**RE: Commercial Development Site Review
111 West Hall Avenue, Slidell, Louisiana**

INDUSTRIAL CHECKLIST

FILE NAME: Northshore Marine

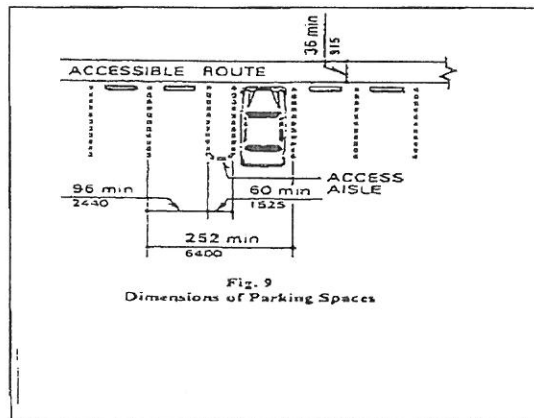
COMMENTS: **Parking spaces are required to be 9' X 20'.**
